Revisions

SHACKERSTONE ROAD

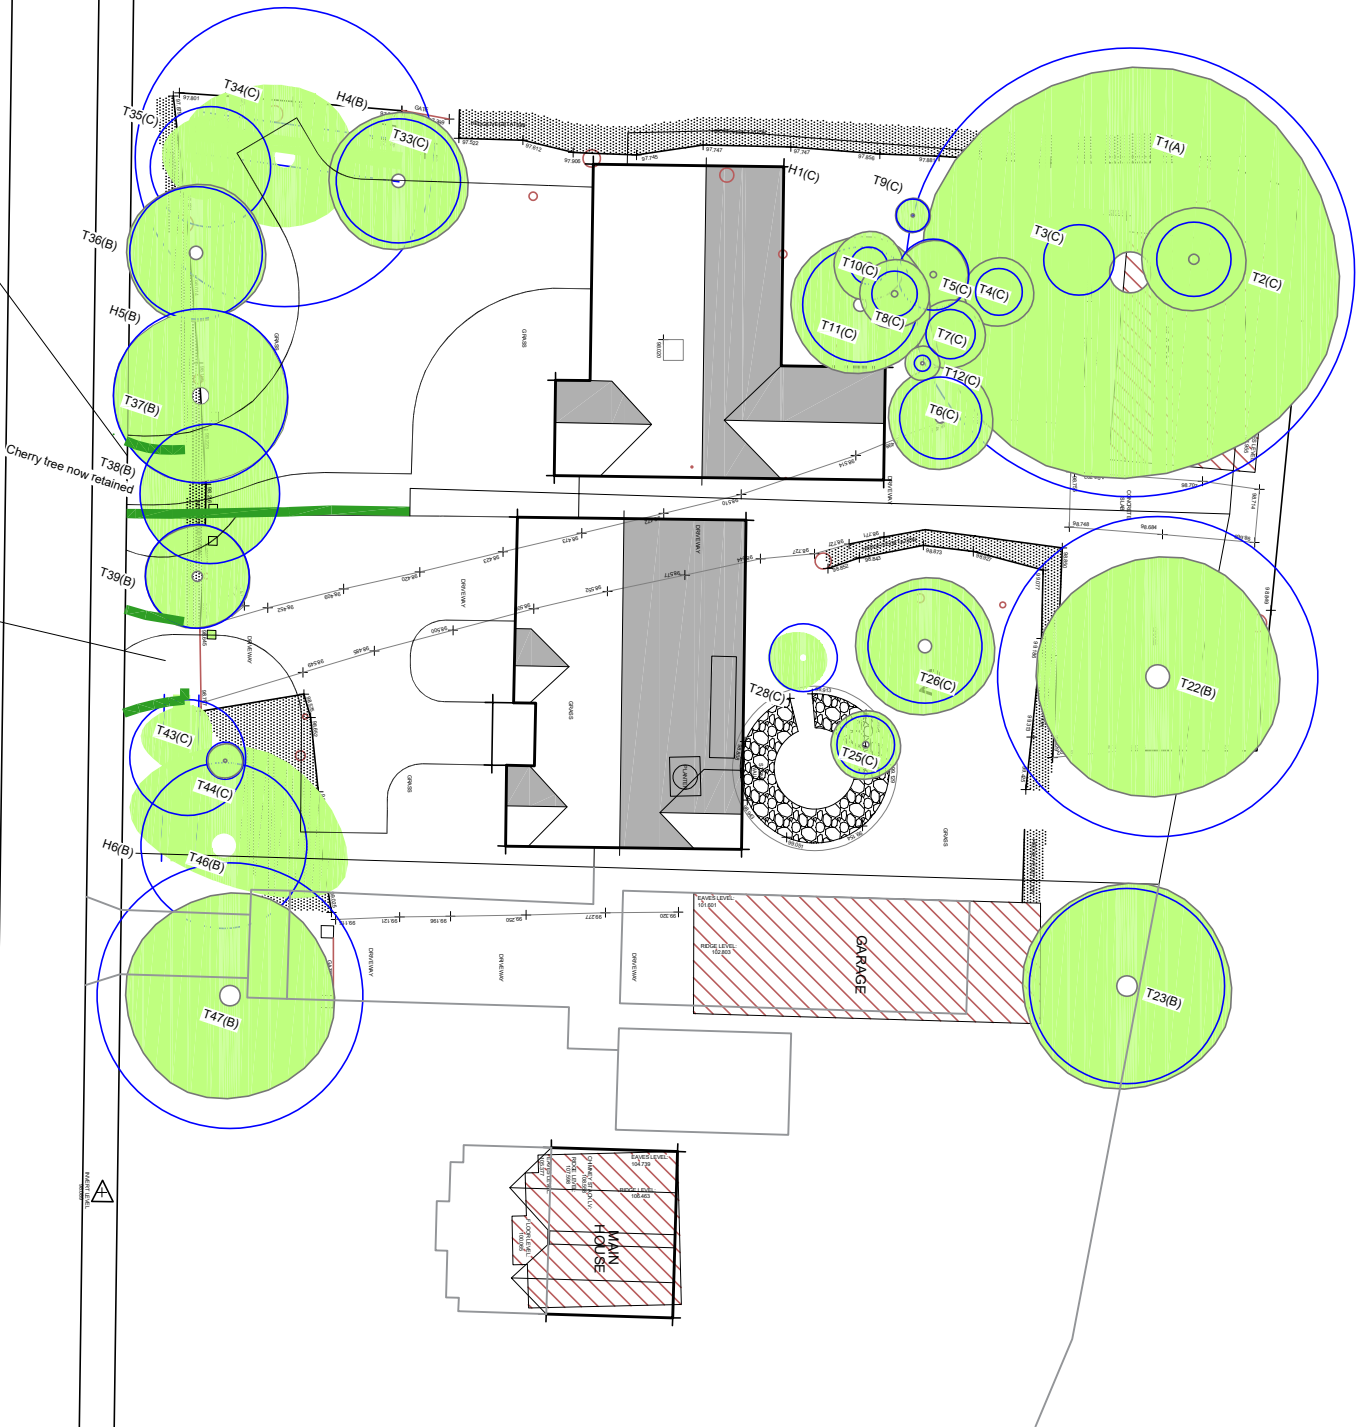
- B - Additional hedge planting shown & notes updated. 07.11.23
- C - Access width reduced, hedges updated, notes clarified and gates removed. 10.11.23
- D - Minor landscape changes. 13.11.23
- E - North point & scale added plus hedge crossing highway footpath removed.
- F - Driveways amended to match all drawings. 22.12.23
- G - T38(b) Cherry tree now shown as a retained. 05.01.24

Additional new beech hedge planting shown. Circa 35m, which will include 4 no. 5m returns from the back of the footpath to comply with LCC highway requirements.

3.25m of hedge removed to provide access to property via driveway. **NO TREE WILL BE REMOVED** to provide the access.

Existing access modified to serve plot 2. Width to be reduced from 6m to 3.25m. The 2.75m width reduction will be provided via new beech hedge planting either side of access.
